Victoria Park

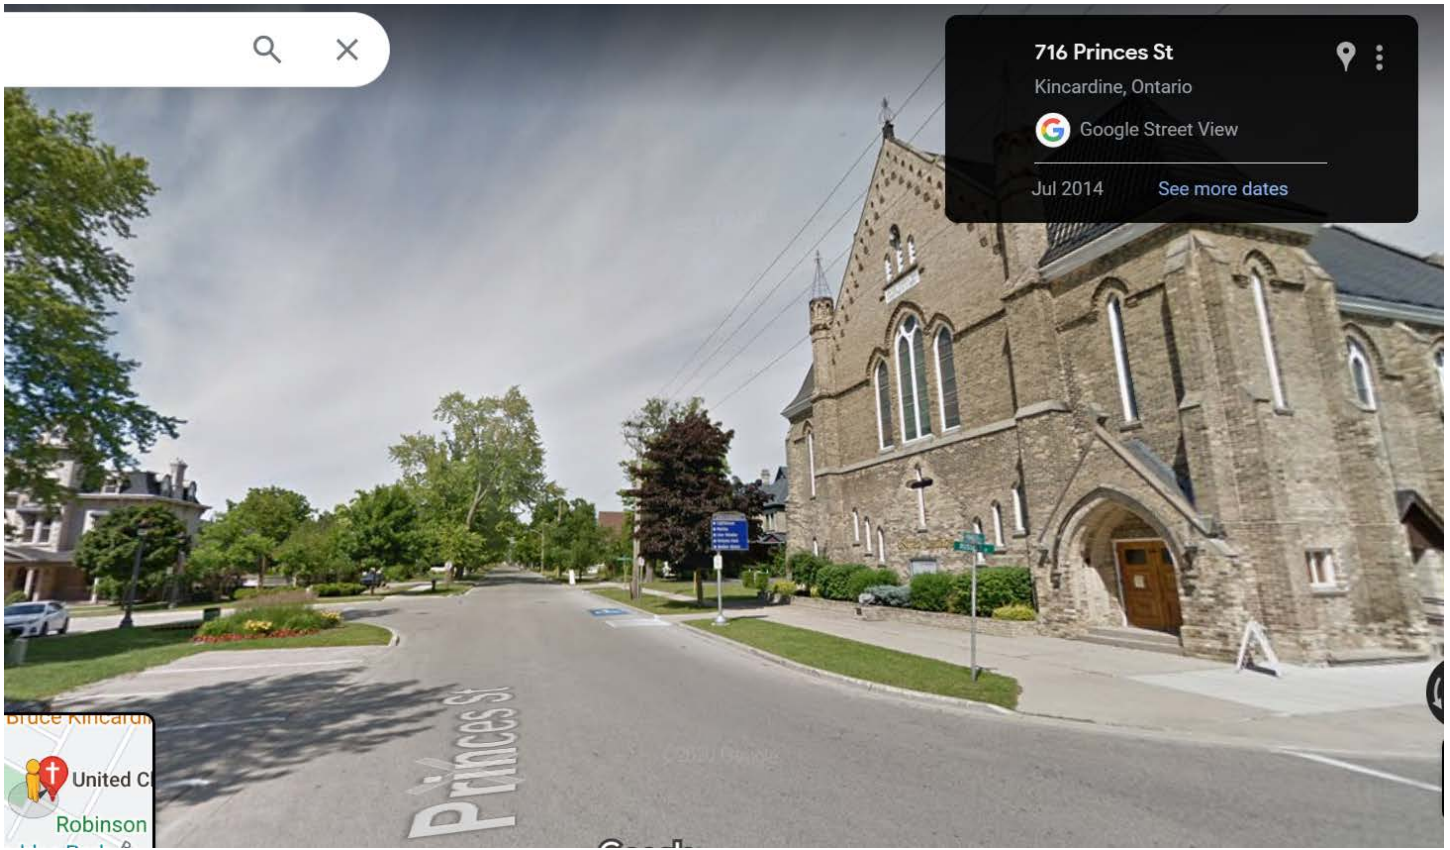
Scott - I feel in the next set of pictures there should be a parking spot at each of the entrances to Victoria Park

AAC – recommends a new spot be installed close to washroom, across from Pet Value – Possibly on NW corner of park – install at each corner of park
